CONDITIONS OF APPROVAL:

Engineering - Final Plat Checklist

[3546121_2017_0911_OVATION RESUB FINAL PLAT REVISION 2.pdf](#)

14. Ovation Lot 3 Improvements

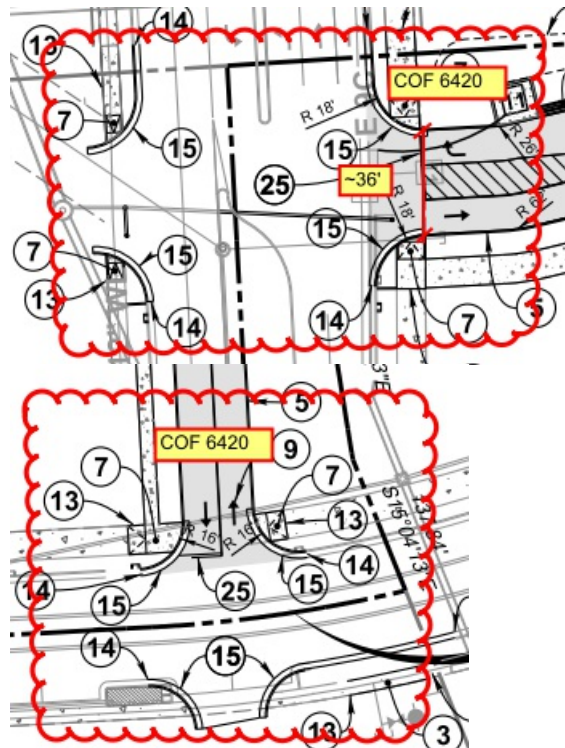
joe.marlo@franklin.tn.gov Comment partially addressed as not all improvements within Public Access Easements appear to be shown.

Applicant to show all improvements within Public Access Easements as shown on the approved Ovation Lot 3 Site Plan (COF 6420), including along work in Ovation Parkway and Tribute Lane. Note specifically the areas in Ovation Parkway and Tribute Lane clouded below.
